From: Hoellman, Jordan
Sent: Thursday, September 15, 2016 4:49 PM
To: Vogle PEmails
Subject: SNC draft LAR-16-008, "ADS and IRWST Injection Block" (PUBLIC)
Attachments: 2016-09-22_VEGP 3-4 LAR-16-018 (WEC 09) Pre-sub Mtg_Draft LAR_Public.pdf

Vogtle Electric Generating Plant (VEGP) Units 3 and 4

ADS and IRWST Injection Block

(LAR-16-018)

• **UFSAR Section 7.2, Figure 7.2-1, Sheet 16 of 20 (change reflected in clouded areas)**

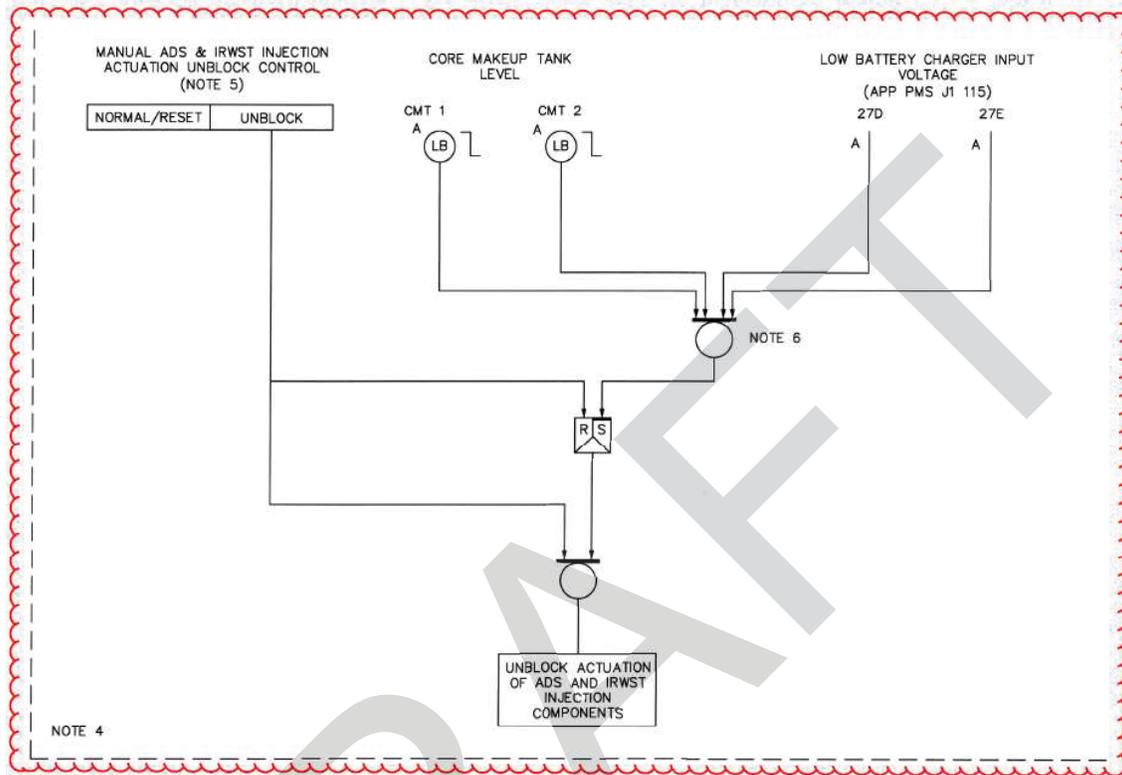
6. THE ACTUATION OF THIS COMPONENT IS BLOCKED UNTIL THE ADS AND IRWST INJECTION ACTUATION LOGIC, SHOWN ON APP-PMS-J1-120, IS SATISFIED.
